Item 8: Houston Import RPG Project

Board of Directors Meeting

Date: April 1, 2014
To: Board of Directors
From: Jeff Billo, Manager, Transmission Planning
Subject: ERCOT Independent Review of the Houston Import Regional Planning Group Project

NRG Comments/Concerns with Houston Import Project

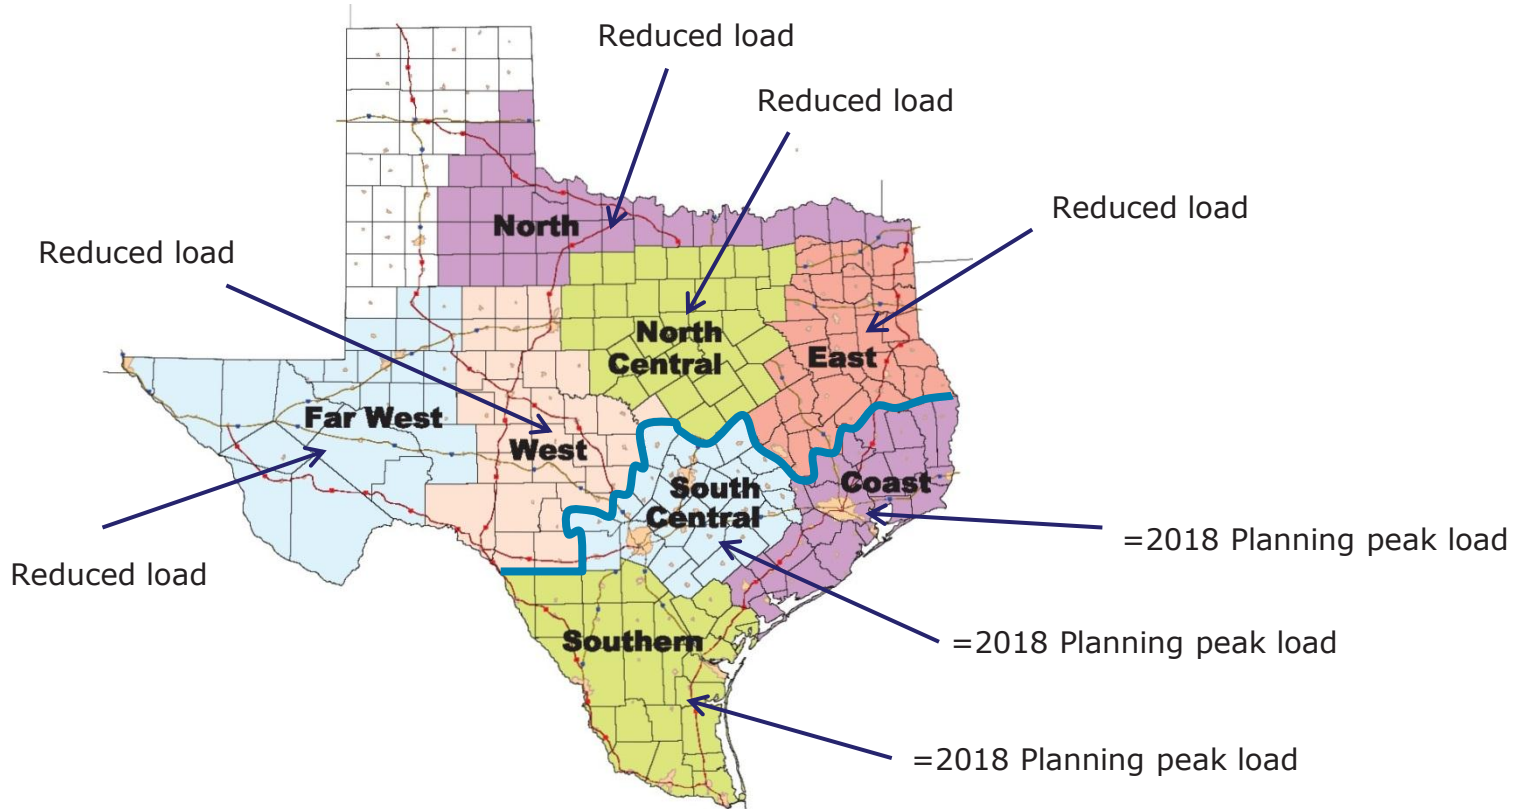
- NRG believes ERCOT's analysis shows the problem being addressed in 2018 by the HIP is a lack of generation, not a lack of transmission infrastructure.

- In fact, ERCOT's final report states there is not enough generation to meet the SSWG Planning non-coincident peak load in 2018, so ERCOT utilized a "load reduction" scaling methodology to handle the problem. From ERCOT's HIP Final Report:

- *"In transmission planning analysis the amount of generation available in the base case may not be enough to meet the summed non-coincident peak load of all areas of the system. In order to solve this challenge... ERCOT split the 2018 summer peak case into two study areas, the so-called NW and SE areas. For each study area the load level was set to the forecasted peak load for that area while load outside of the area was scaled down until there was enough generation to meet the load plus an operational reserve of approximately 1375 MW."*

- A planning assumption of reduced load in one area of the state is electrically equivalent to adding that same amount of generation in that area.

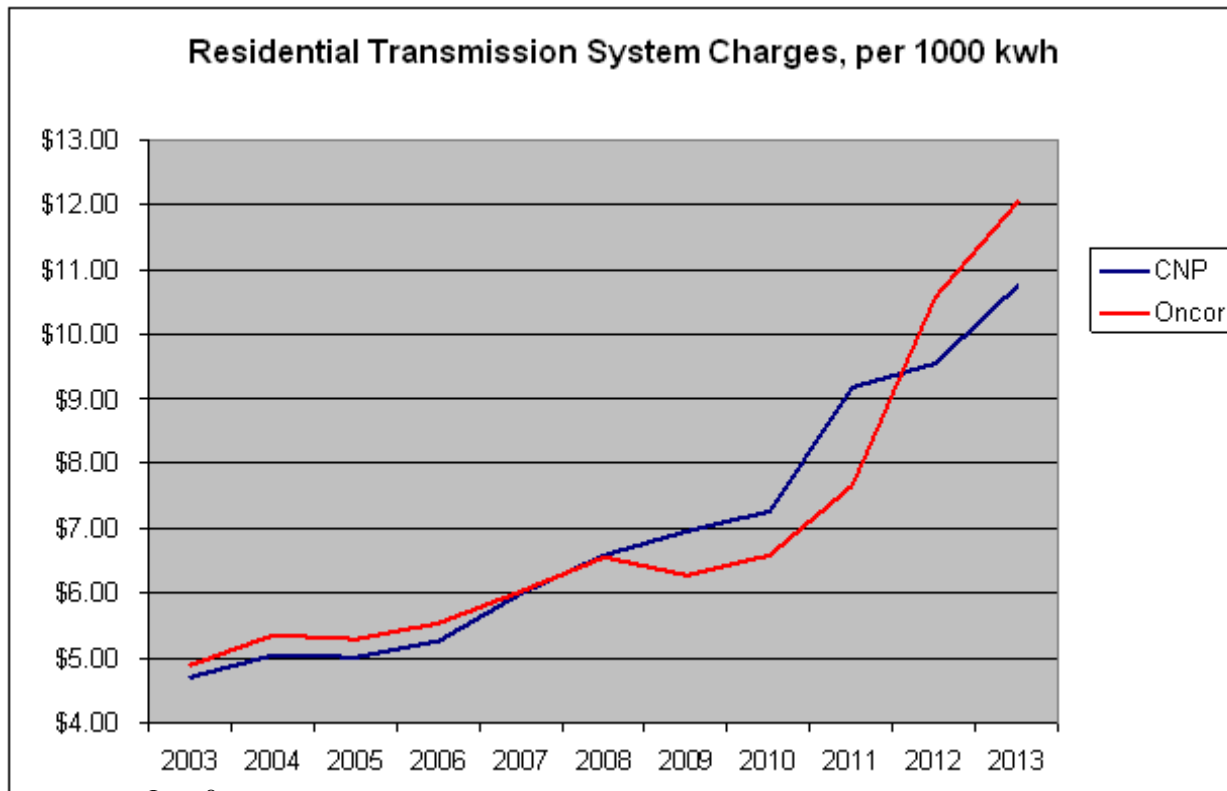
- For example, the peak load in 2018 for the Coastal region in the HIP analysis is 26,355 MWs. ERCOT's 90/10 (extreme weather) forecast from the 2013 Regional Transmission Plan ("RTP") shows a 2018 peak load in the Coastal region of 24,475 MWs.

- The North Central weather zone peak load in 2018 in the HIP analysis is 25,895 MWs, while ERCOT's 90/10 forecasted peak in the RTP is 29,512 MWs.
- These differences in the load forecasts exacerbate the load scaling issues described in this presentation (an example is provided on the next slide).

- Should one load forecast be used when discussing generation reserve margins in the CDR, while another load forecast is used to plan transmission?
- NRG believes the answer is No.
